EDITOR'S COMMENTS

The article by Tubiana et al. describes observations of the JANUS camera system during LEGA. Its purpose (in my view) is to provide an overview for science and calibration to be performed on this data set and provide an exemplary template for coming (Jupiter system) observations. I consider instrument operation during cruise essential and much appreciate the effort to provide a clean article like this.

Histogram of three subsections of JANUS images in Figure 4. Each subpanel contains 150x140 pix and represents the same area although observed on a slightly different time from a slightly different perspective.

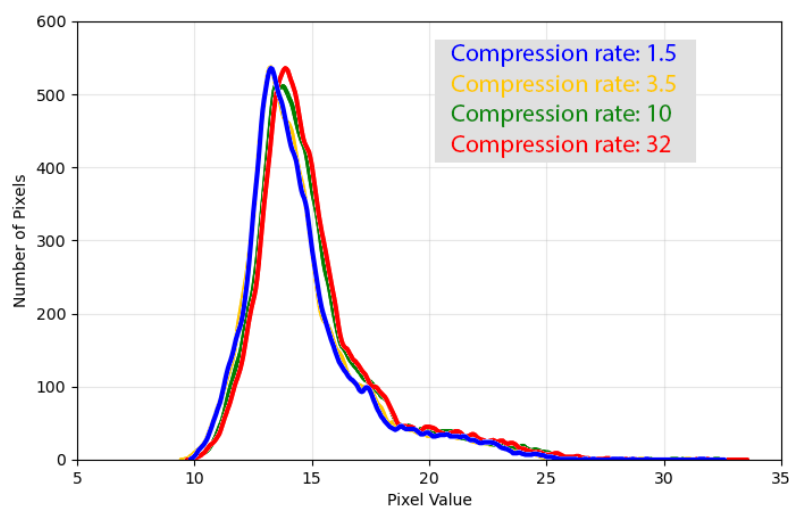
L165-170: I realise that the authors say that the results of the compression test are preliminary, but I wonder if there is any way that they can show how well photometric accuracy is preserved? I agree that there is no visible degradation of the image quality with compression, but are pixel-to-pixel brightness variations affected? Perhaps showing some image histograms for the lower panels of fig 4 would be a way to do this? Alternatively, if a more detailed analysis is planned, perhaps the authors can simply cite the (in prep?) paper that will look at it.

Fig. 4: Several issues keep me from judging the quality. First, I do not know the pixel size and processing steps applied to the bottom line. I assume that compression acts like a smear. Is this correct? That depends on the actual compression algorithm applied, which is not provided. I would be able to see compression artefacts only if I can see individual pixels. Zooming into the image, Firefox & Adobe Reader seem to apply some sort of filtering (Lanczos or such). That’s how far I went. Please provide some more information.

REPLY: A quantitative analysis of the effect of compression on the image quality and the photometric accuracy is planned and will be carried out in the next months, but it is not yet ongoing. We have modified the figure to show three images with compression ratios of 1:1, 3.5:1, 10:1 and 33:1. Compression effects are very small at small to moderate compression rates and some degradation is observable at compression rate 10, with sharp horizontal and vertical lines that are added over the structures in the images. Since lunar images have very strong contrast these lines are better observed when displaying a high-pass filtered version of zoom-up versions of the images (bottom row in figure 4). A very strong compression ratio of 33:1 produces strong artifacts that degrade the visibility of small craters present in the images. Radiance values from these images are nearly identical and histograms of common regions in the images show nearly identical results. We believe including histograms of these images is not needed as rows 1 and 2 in Figure 4 are shown using exactly the same radiance range showing strong consistency in the pixel values. Histograms of the four small panels in row 2 in Figure 4 are given below but we think adding those histograms in the manuscript would remove part of the focus. We have updated the figure and text in the manuscript. We have also updated statements in the manuscript about future observing strategies and data.

REPLY: info about the compression algorithm added in the camera description (line 68, added: JANUS is equipped with a compression unit that compresses the data using a standard wavelet compressor, allowing both lossless and lossy compression up to a factor 33:1.). Additional details about the very preliminary assessment of the compression analysis has been added following the request of referee 1.
